CLAREMONT BUSINESS PARK 2

“AMENDMENT” OF THE PRELIMINARY DRAINAGE REPORT FOR

CLAREMONT COMMERCIAL SUBDIVISION FILING NO. 2 A RESUBDIVISION OF TRACT C OF CLAREMONT BUSINESS PARK FILING NO. 2

JULY 2020

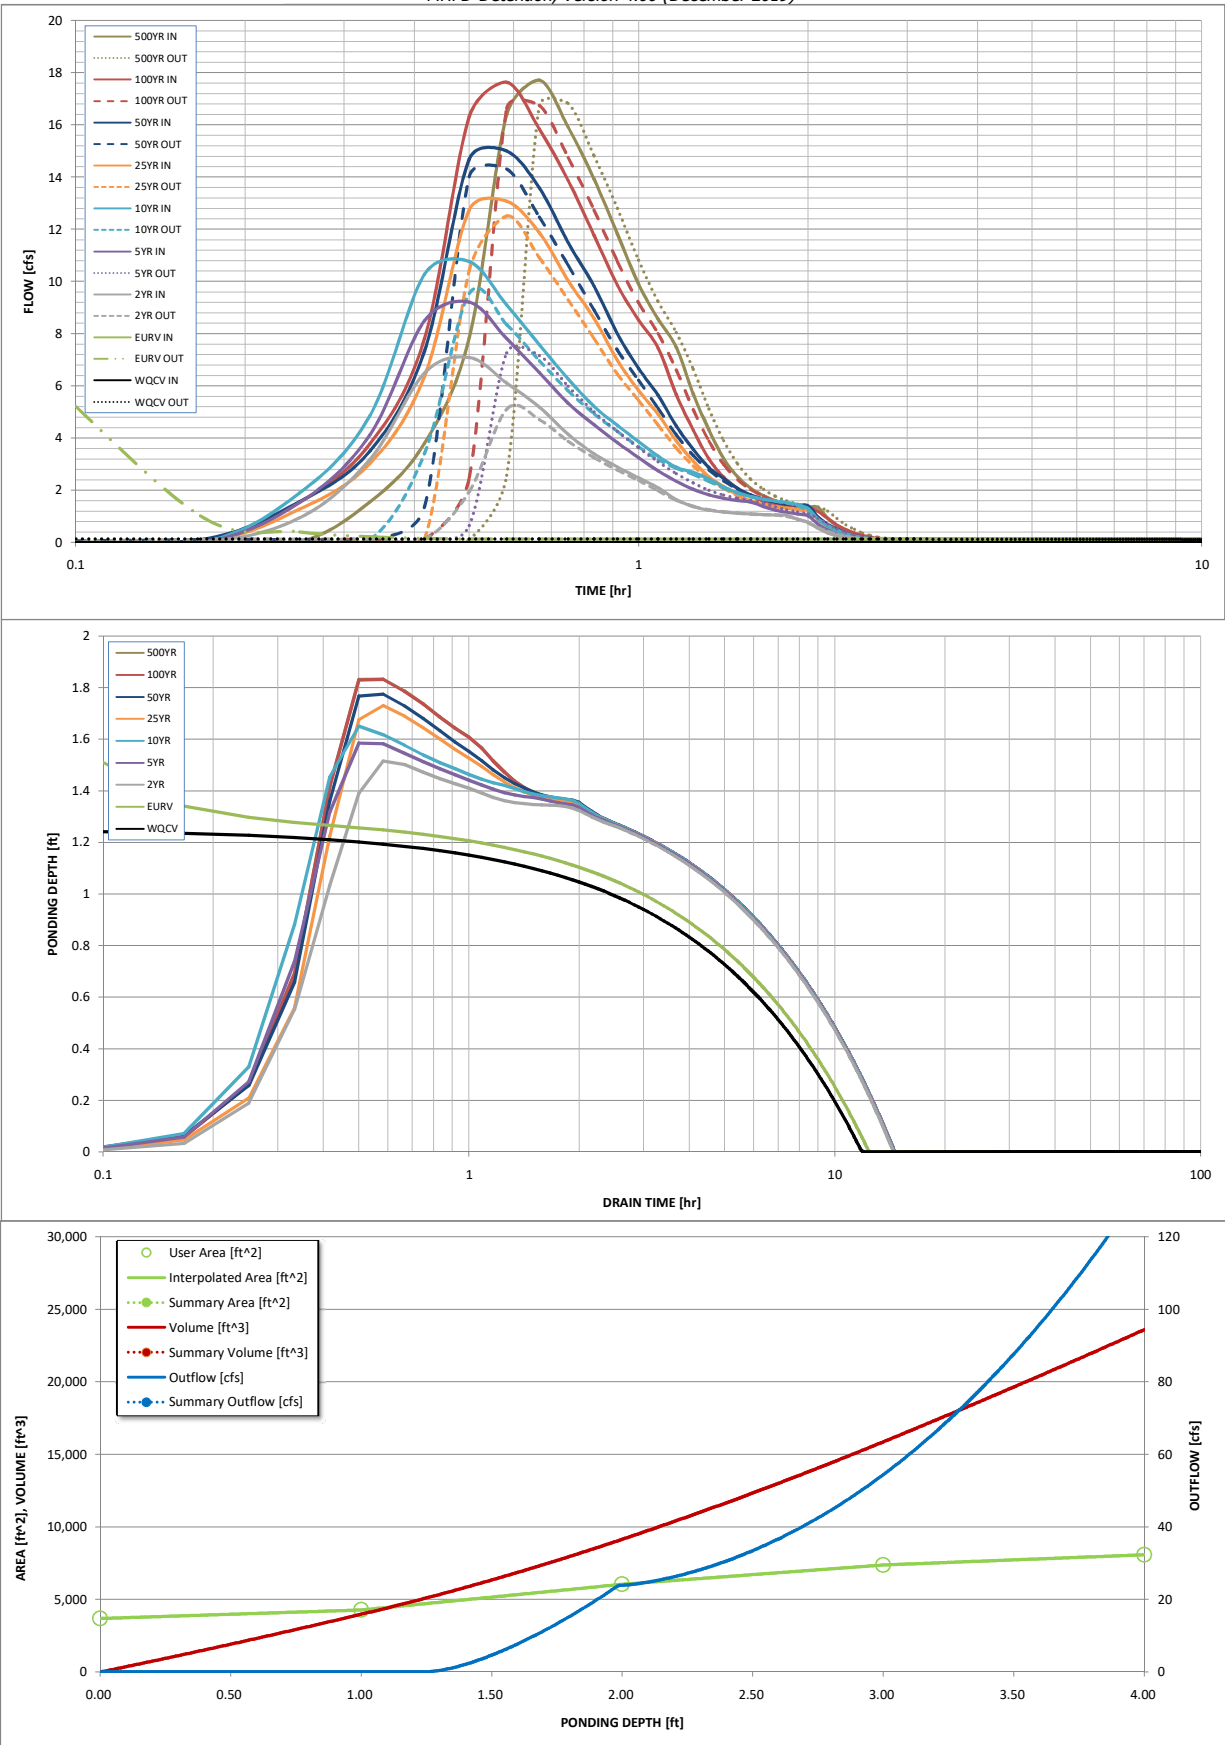
Should be Claremont Business Park Filing No. 2

COMMENT ADDRESSED

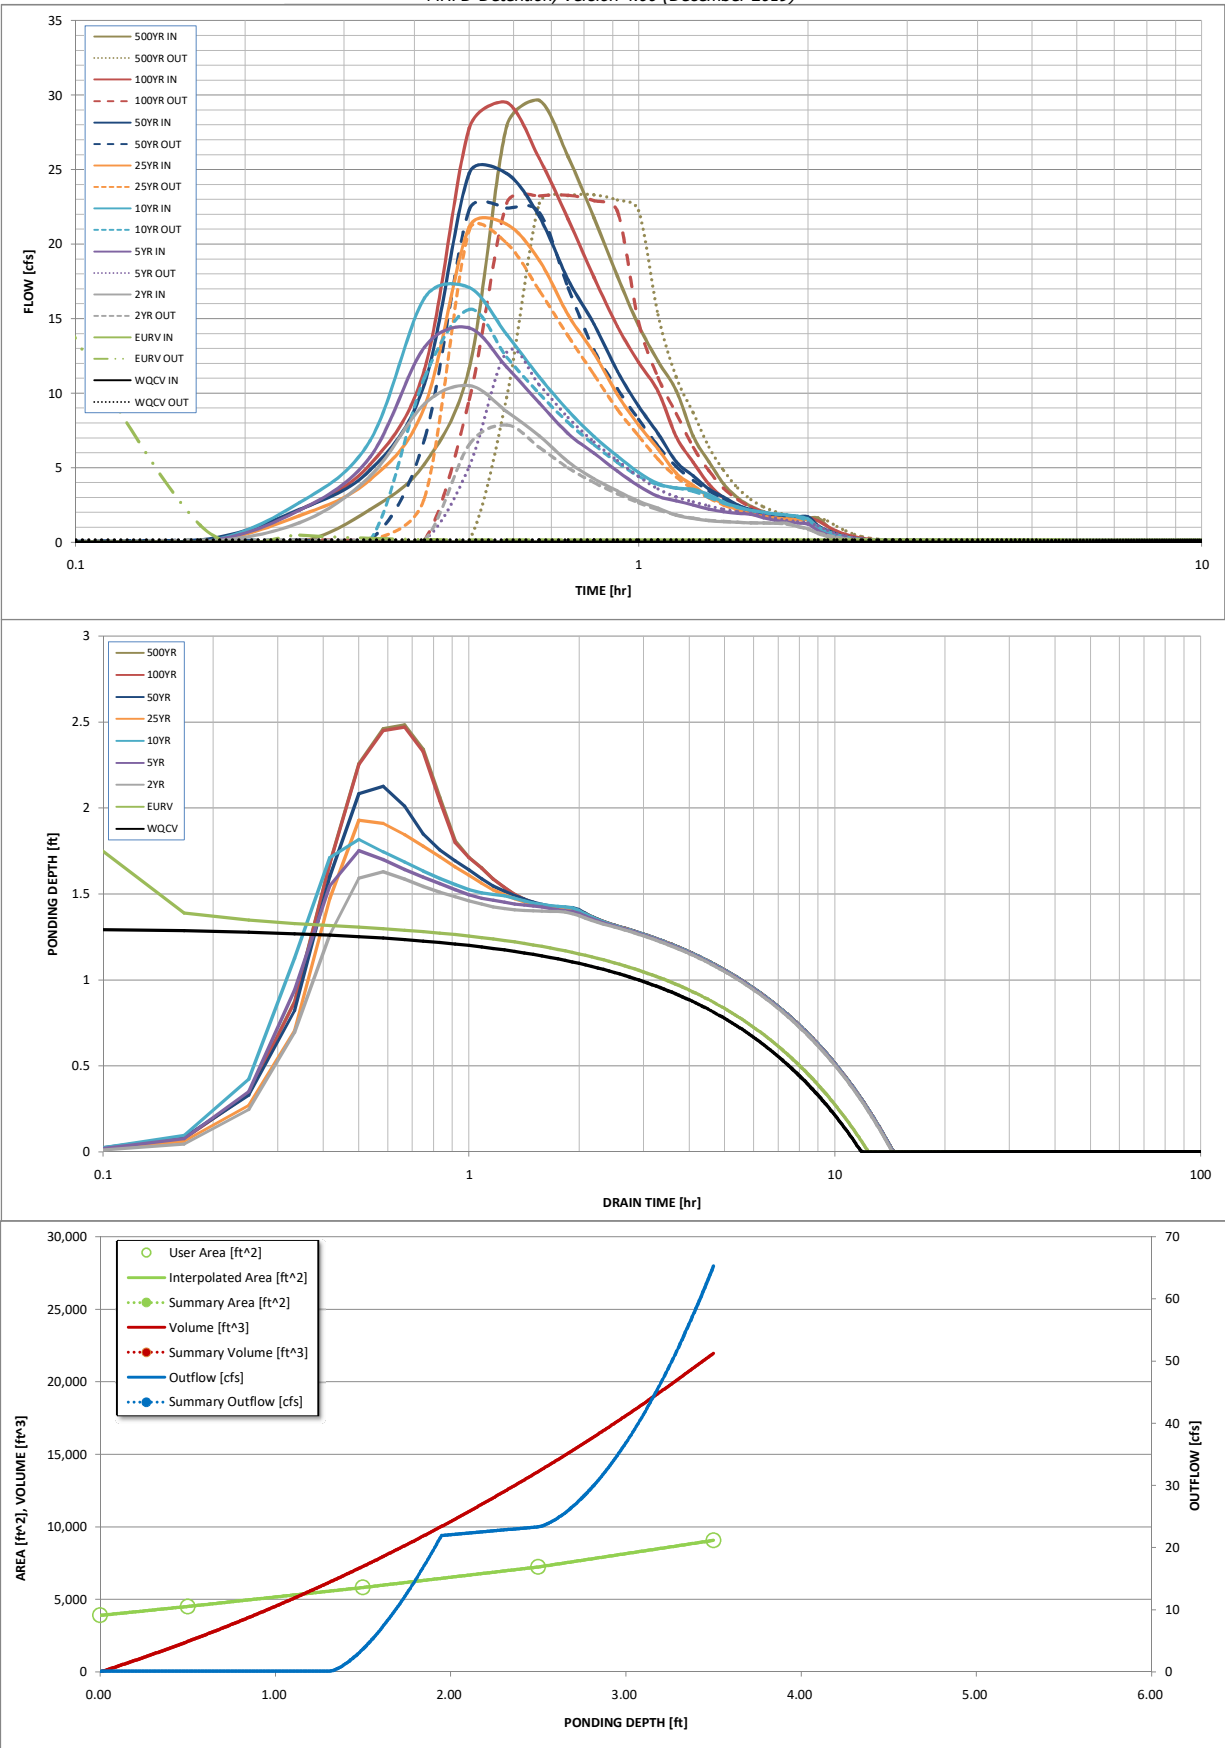
Should be Claremont Business Park Filing No. 2

COMMENT ADDRESSED

CLAREMONT BUSINESS PARK 2				
PROPOSED DRAINAGE MAP				
PROJECT NO. 44-037A	FILE: \dwg\Eng Exhibits\44037-PDRM.dwg	DATE: 07-01-2020		
DESIGNED BY: GW	SCALE: HORIZ: 1"=60'			
DRAWN BY: CLP	VERT: N/A			
CHECKED BY: VAS				
		SHEET 1 OF 1		PDM01

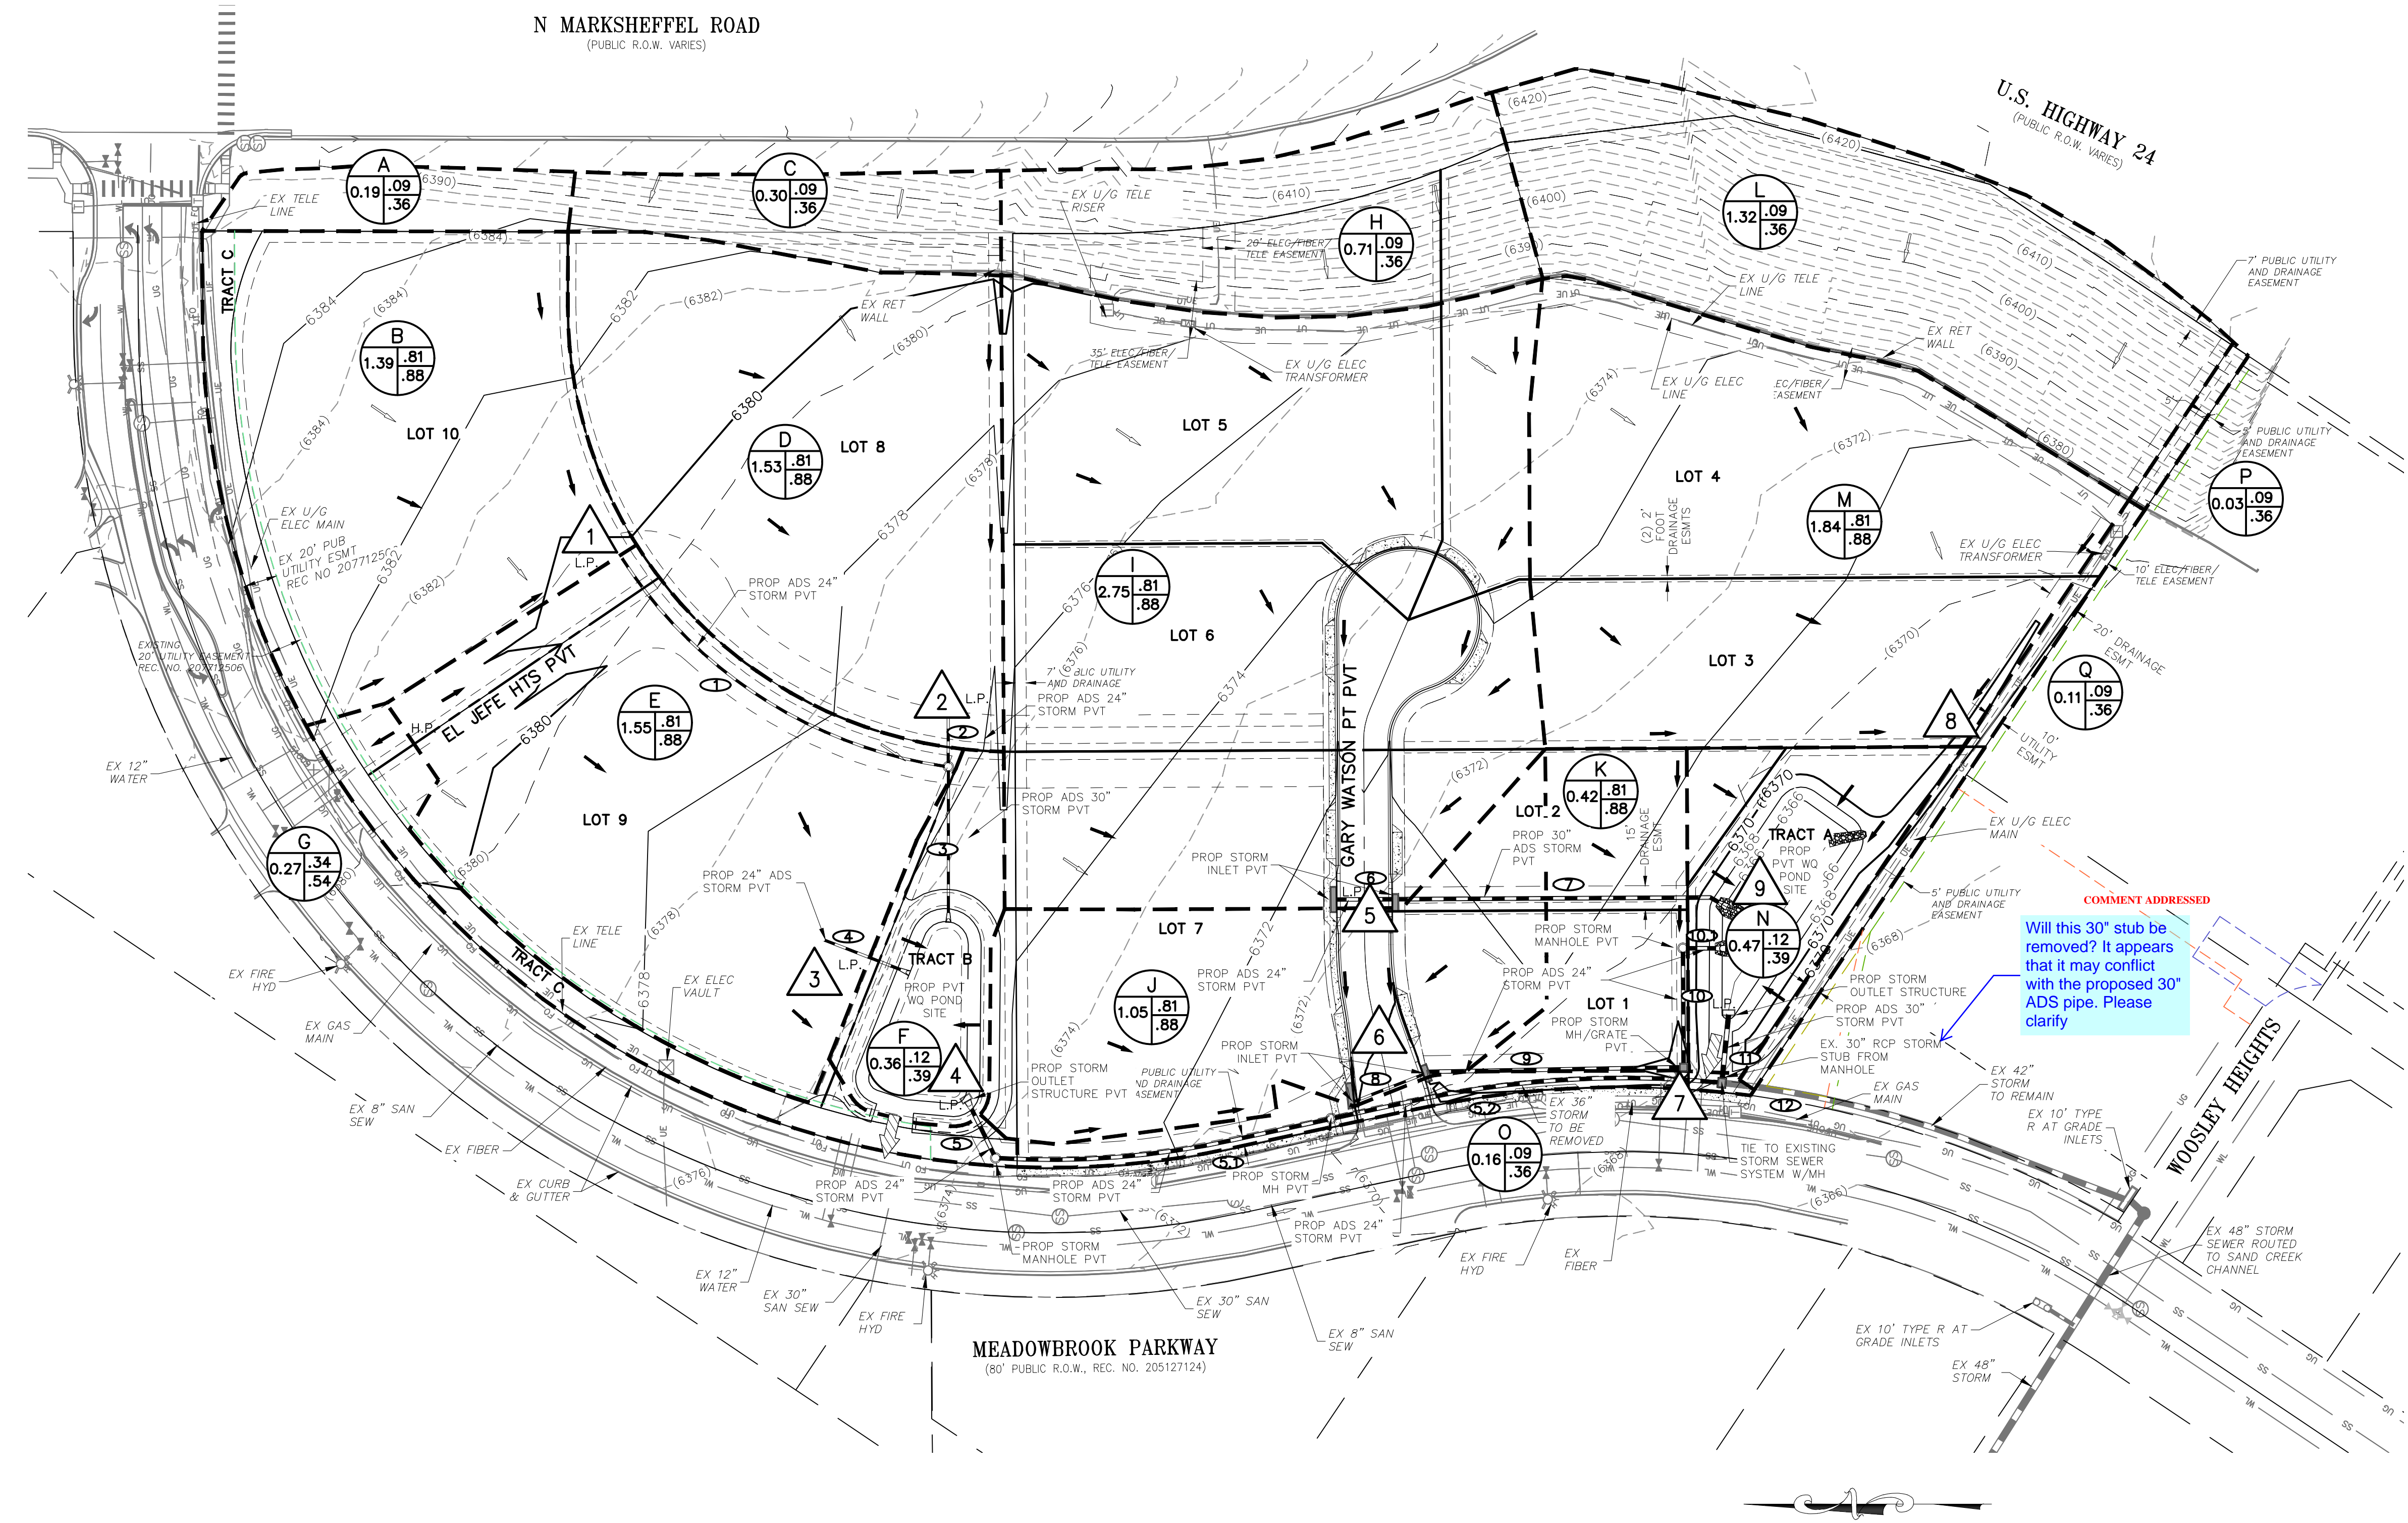
Please provide the
drainage map at the
end of the report.

COMMENT ADDRESSED
